Mount Piper to Wallerawang Transmission Line Upgrade Project

Submissions Report

December 2025

Figure 3.4. Access tracks that have been re-categorised – Map 4

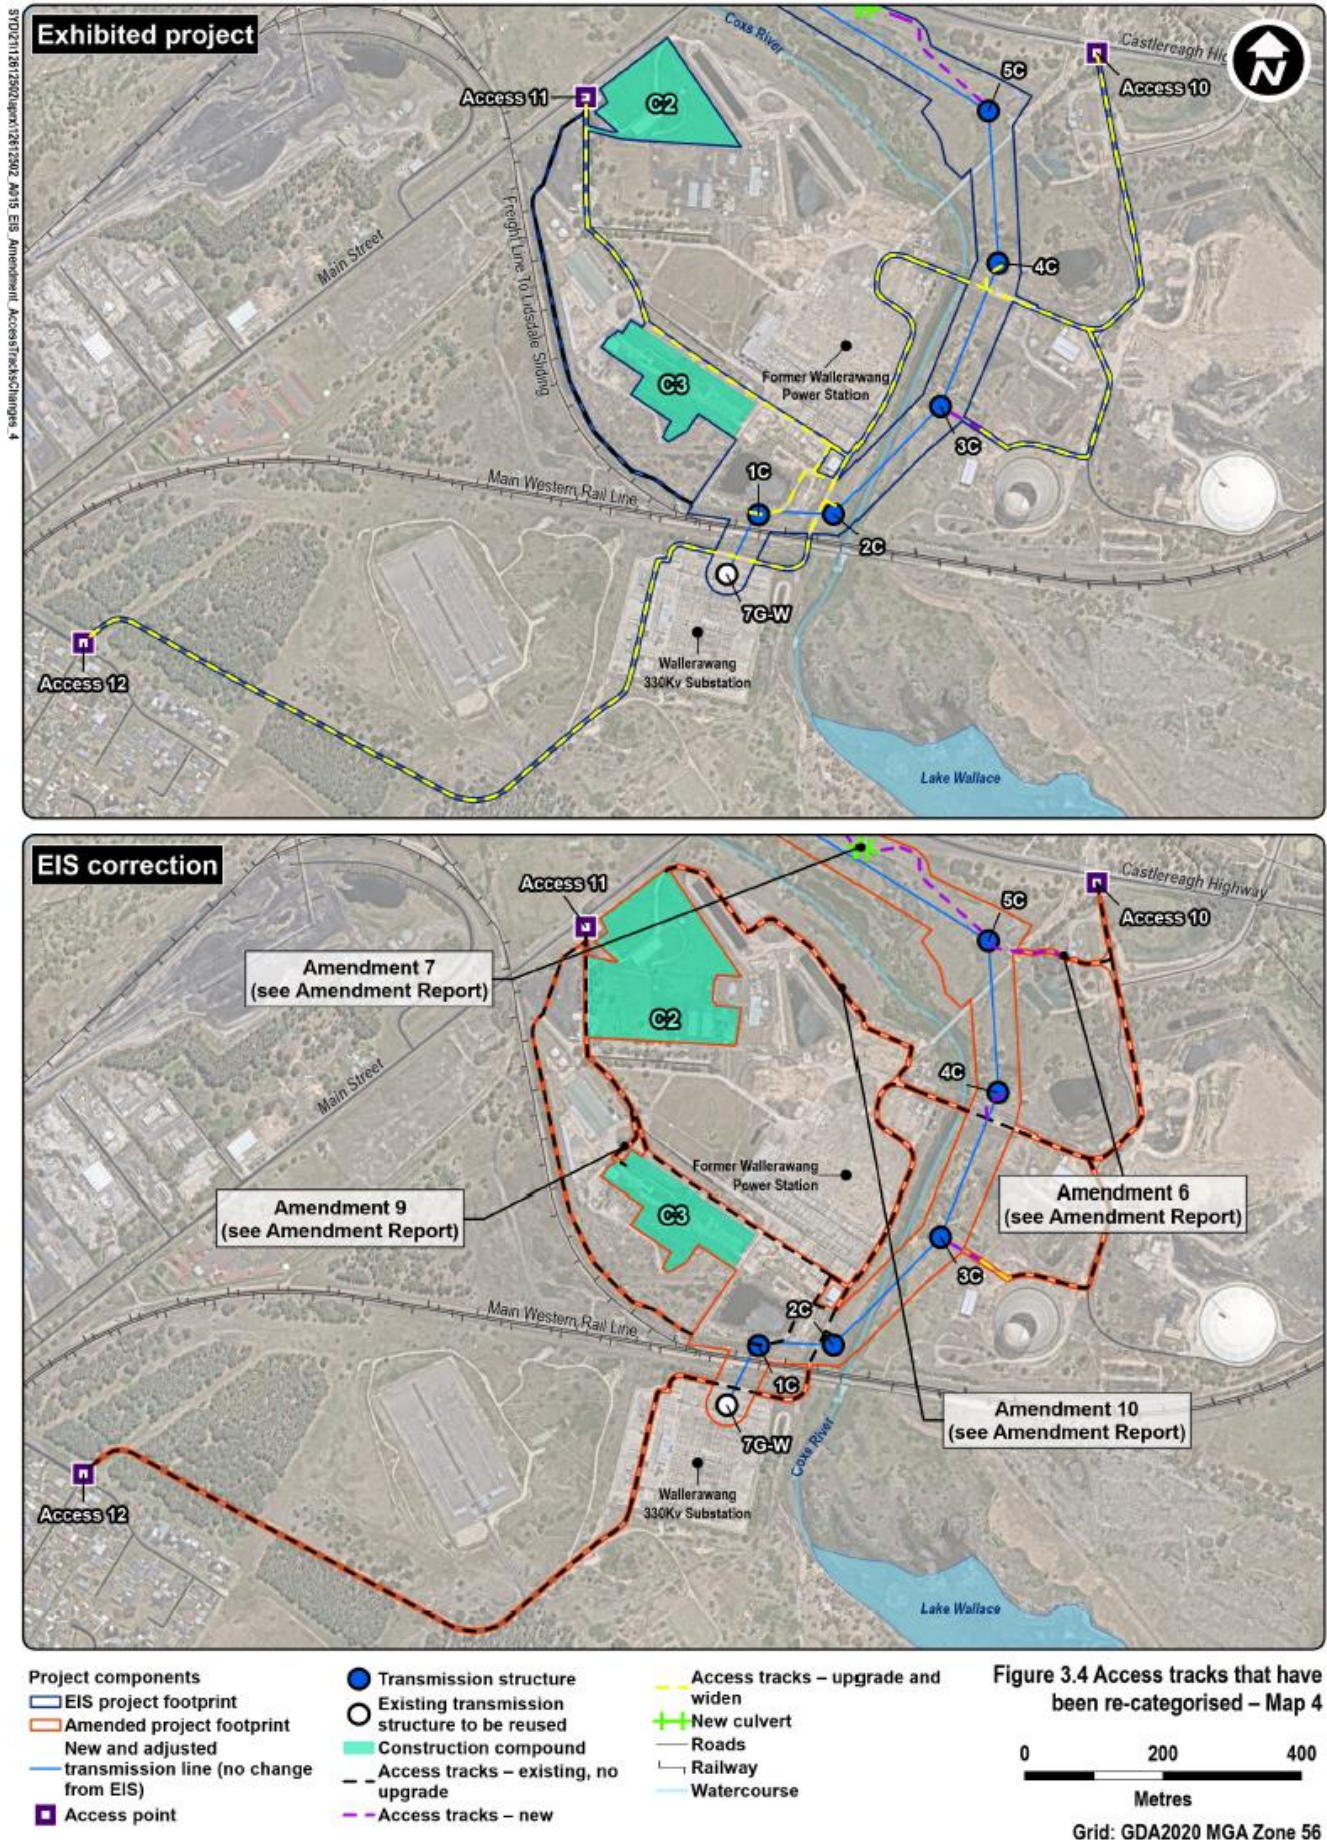
Since exhibition of the EIS, it was identified that some existing tracks were incorrectly identified as requiring upgrade and widening. This was mostly related to tracks located on properties owned by EnergyAustralia, Centennial Coal and on the former Wallerawang Power Station site. These tracks have been re-categorised and are shown in Figure 3.1 to Figure 3.4. The re-categorised tracks are also outlined in the Amendment Report (Transgrid, 2025a) and the revised project description (Appendix A of the Amendment Report).

Figure 5.1. Revised Figure 6-2 from ACHAR for pedestrian coverage – Map 1

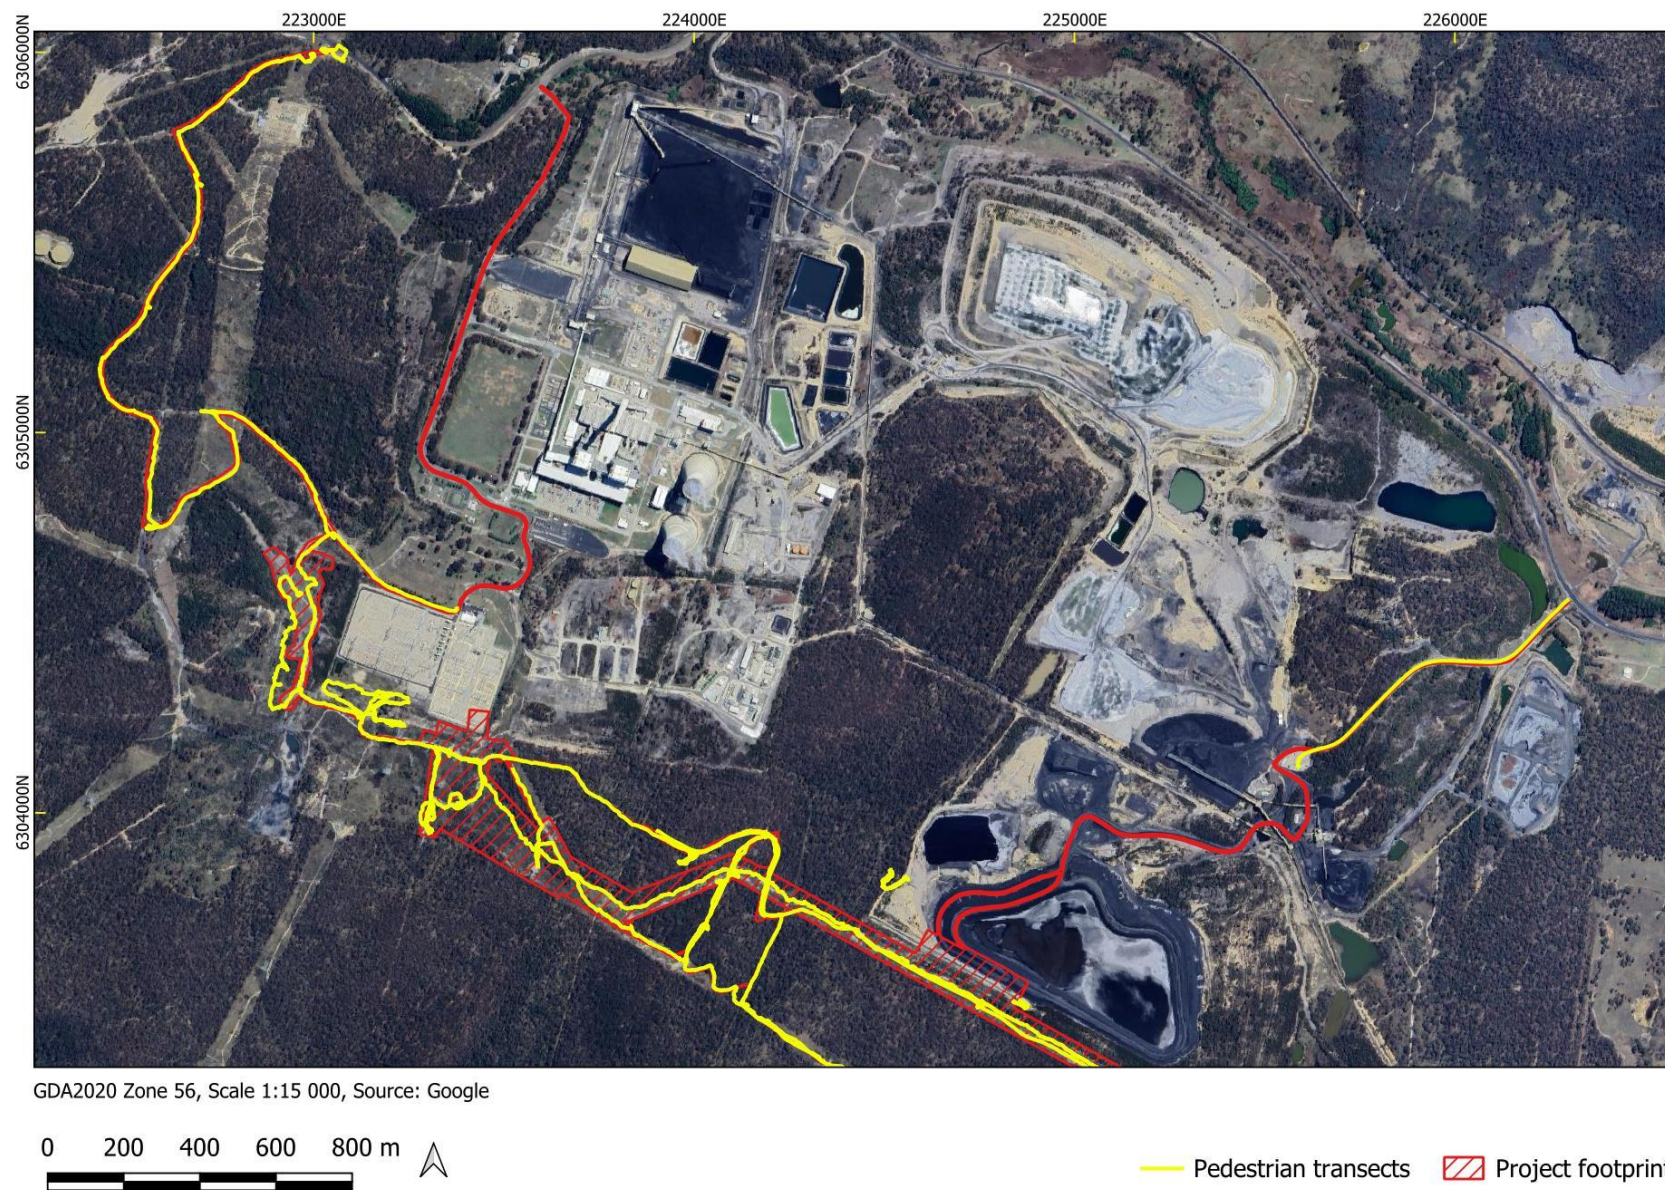
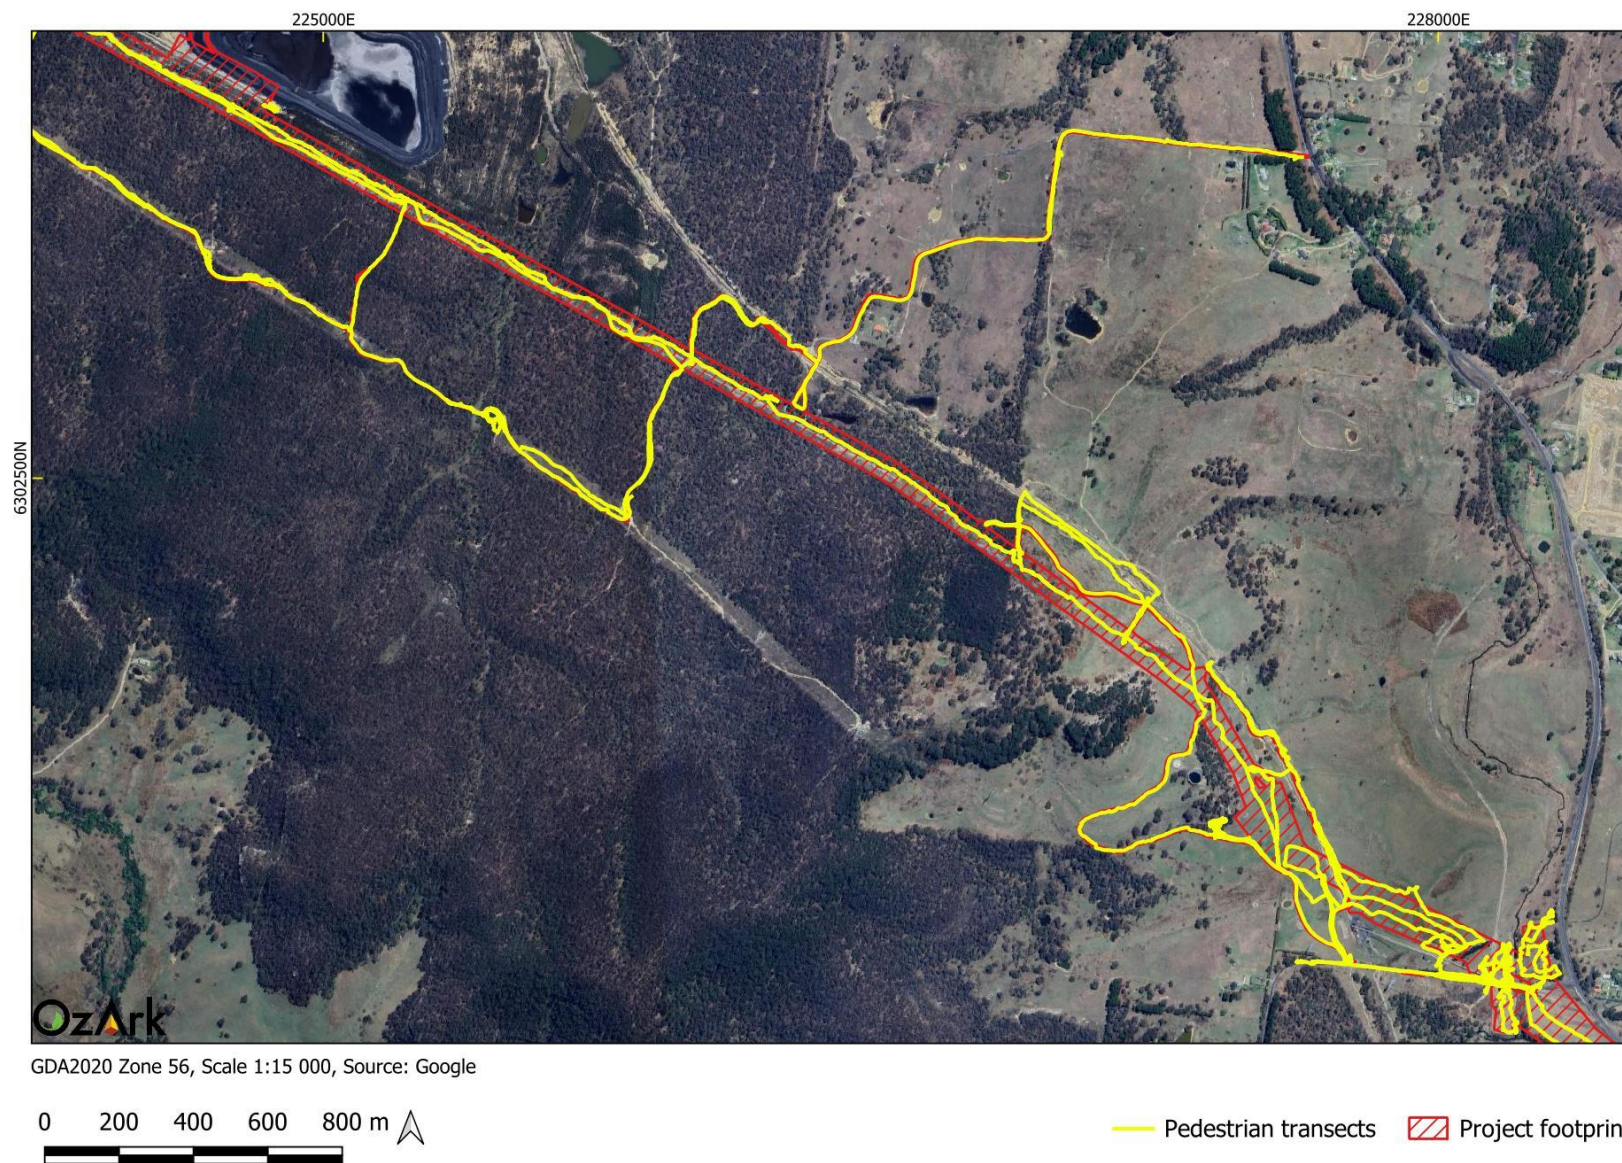
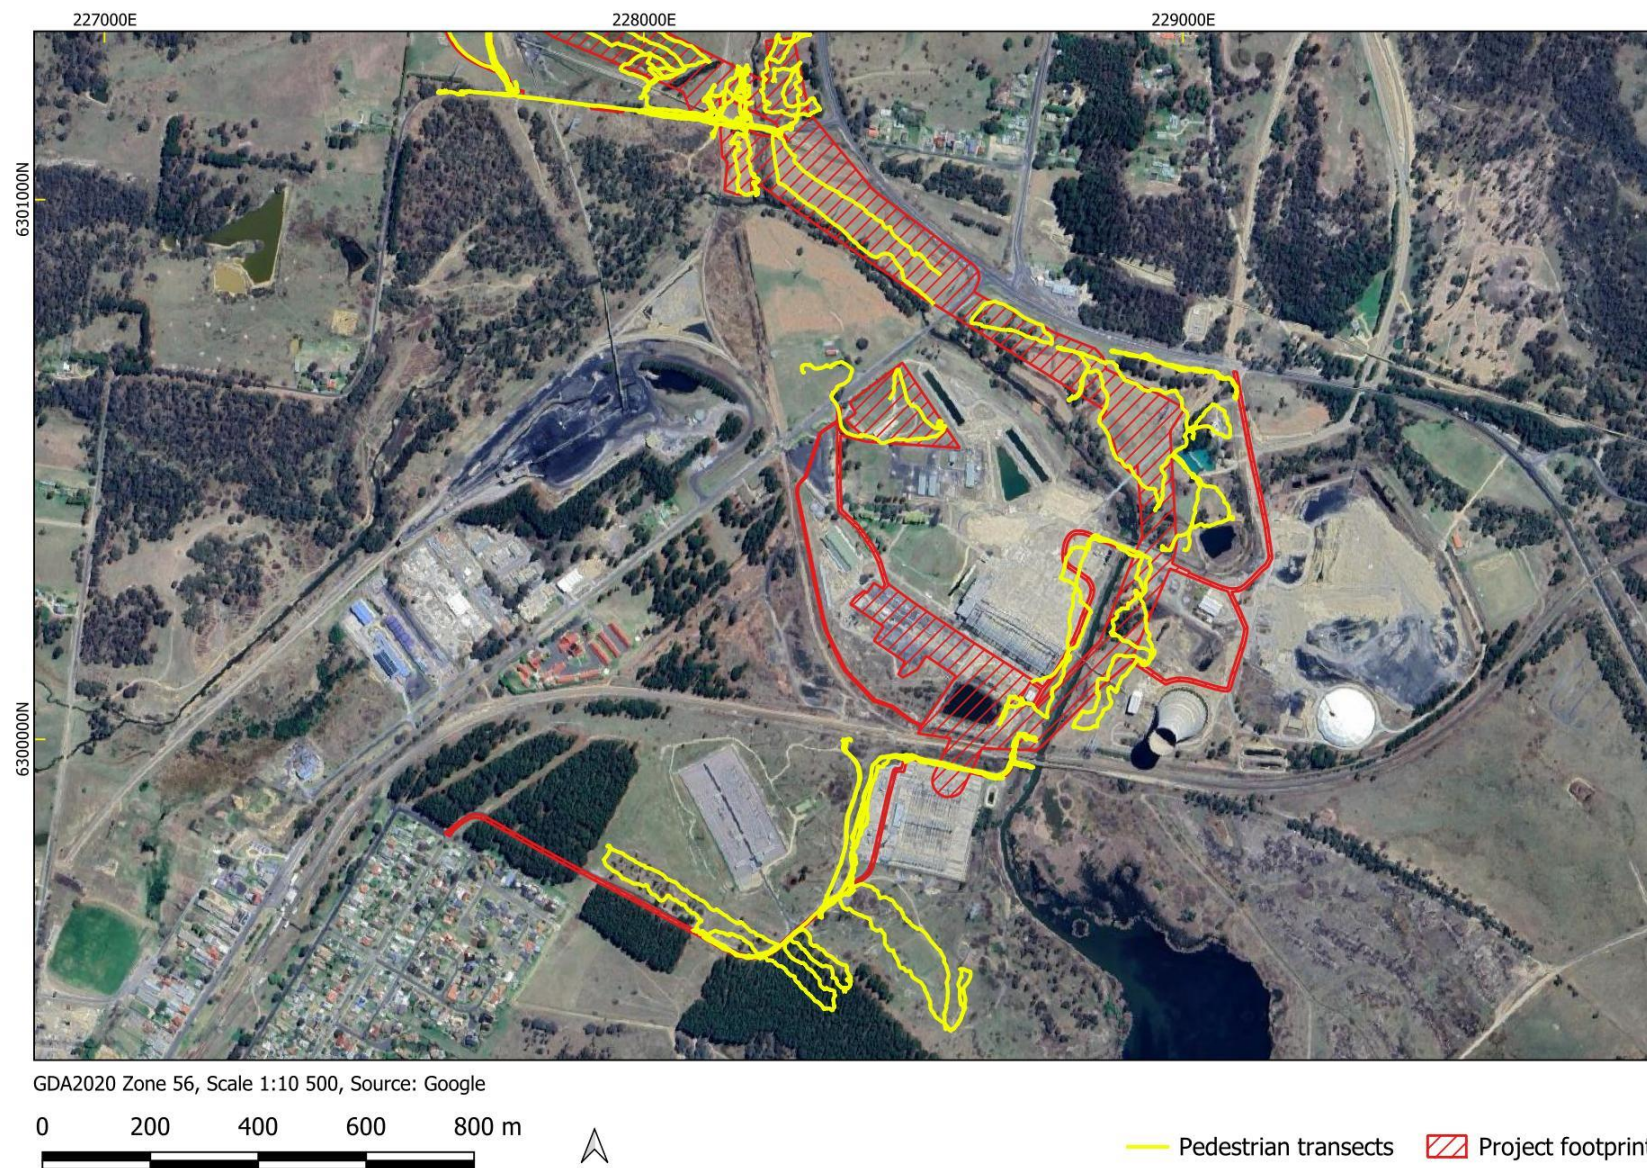
<p>Please update the mapping provided in Figure 6-2 of the ACHAR to provide greater context to the track logs by reducing the mapping scale.</p>	<p>Mapping provided in Figure 6-2 of the Technical Report 5 – Aboriginal Cultural Heritage Assessment Report has been updated reducing scale to improve readability of the pedestrian coverage of the field survey. The updated figures are shown in Figure 5.1 to Figure 5.3 below.</p>
<p>Please clarify the number of test units excavated as a part of the excavation program. Section 7.4 states that 18 test units were excavated, but Figure 7-3 and Table 7-3 indicate that 17 test units were excavated.</p>	<p>A review has confirmed that 17 test units were excavated. Mention of 18 test units in section 7.4 is a typographic error.</p>

Figure 5.4. Updated Figure 6.11 from EIS – Noise contours of audible corona noise in L50 conditions

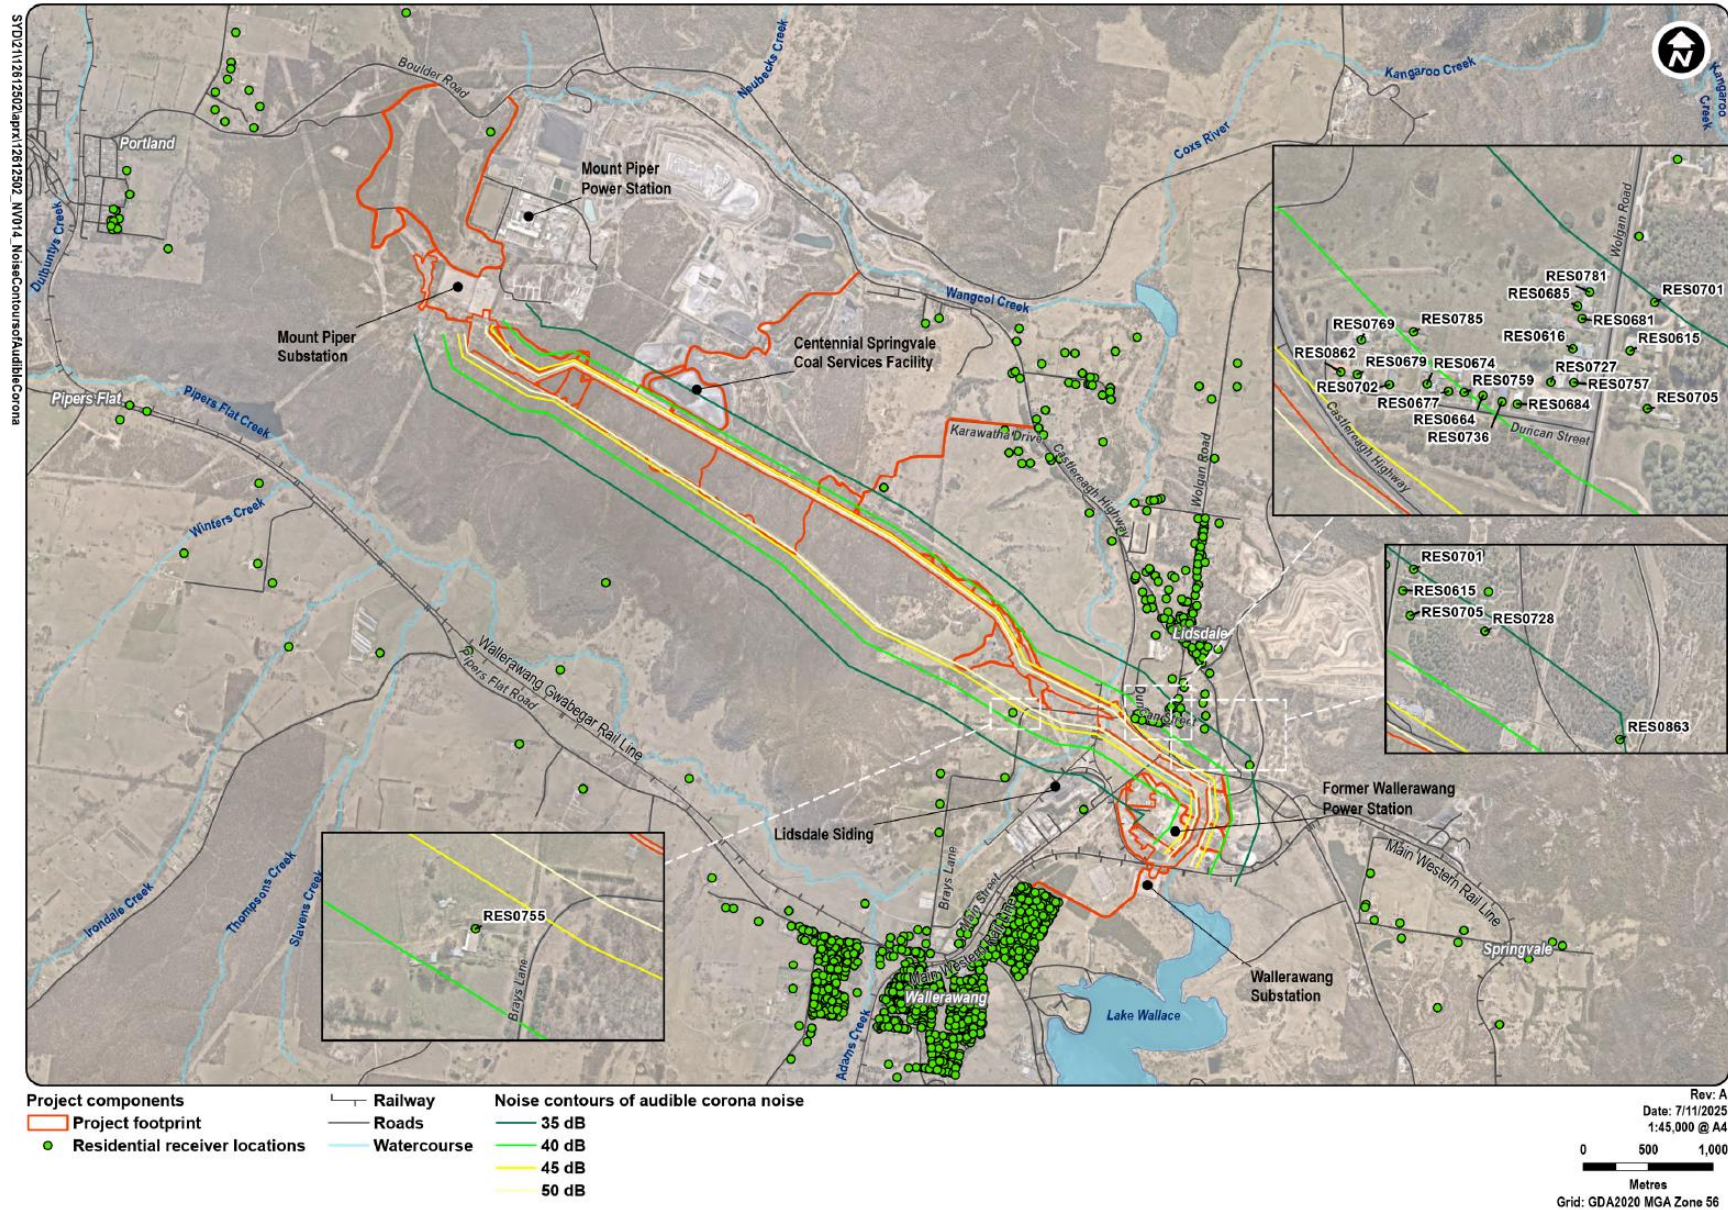
<p>Exceedances of corona noise levels are identified at nine additional receivers compared to the existing situation. Provide anticipated noise levels at RES0863 (noting that the remaining eight receivers can be identified on the noise contour map in Figure 6.11).</p>	<p>Figure 6.11 from the EIS has been updated to include labelling of RES0863. This is presented as Figure 5.4 in this Submissions Report and shows the anticipated noise levels at receiver RES0863 as well as all other receivers.</p>
<p>Outline the change, if any, in corona noise levels at the residential sensitive receivers already experiencing corona noise.</p>	<p>The change in corona noise levels is described in section 8.4.2 of the EIS. The modelling suggests that of the 14 sensitive receivers that could already be experiencing potential exceedances of the assessment criterion for light rain conditions, nine receivers could be subject to an increase in corona noise of around 3 dBA as a result of the project.</p>
